HLW REPLACEMENT PARTS

WATERERS - 11 NOV/2021

WATERER COMPONENT HISTOGRAM

HEATED LIVESTOCK WATERERS VALVE & FLOAT

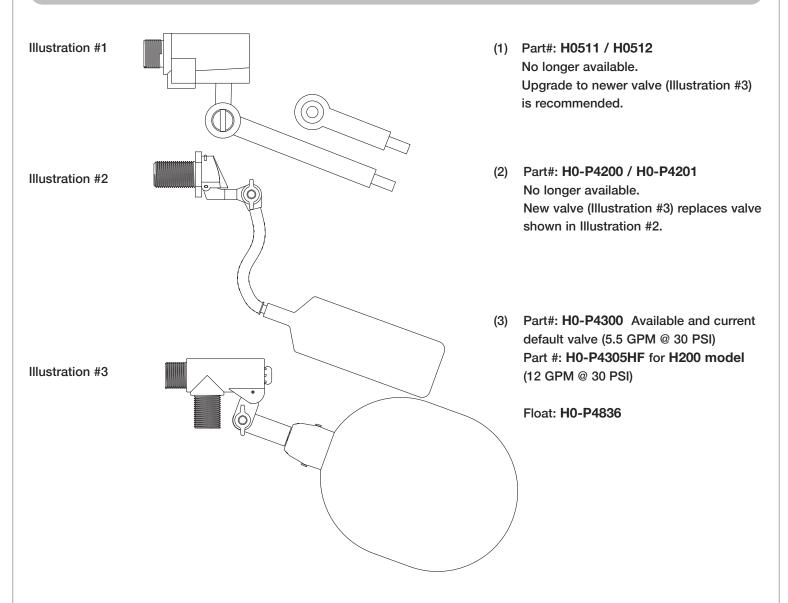
- 2001 Post-1994 valve assembly (see Illustration #1) required costly design upgrade for high water pressure (PSI) locations. Research thus began for alternate valves.

- 2003 An alternate valve (see Illustration #2) was found, tested and approved to cover high PSI locations with fair results for low PSI locations. Decision was made to completely switch to this valve.

- 2005 Feedback indicated that low PSI locations needed greater water flow. Valve supplier was immediately contacted for further development. In the interim however, low PSI users were told to purchase the post-1994 valve (Illustration#1) with an updated plastic float as a replacement assembly.

- 2006 A redesigned, more robust valve (Illustration #3) with improved sealing and a larger orifice size (with capacity for further enlargement) was soon developed, tested and approved. All 2006 waterers will have this new valve (Illustration #3).

- A high flow valve has been added for the H200 waterer. It is rated for 12 gal/min at 30 psi. See replacement part #H0-P4305HF. It is retro-fittable to older models.
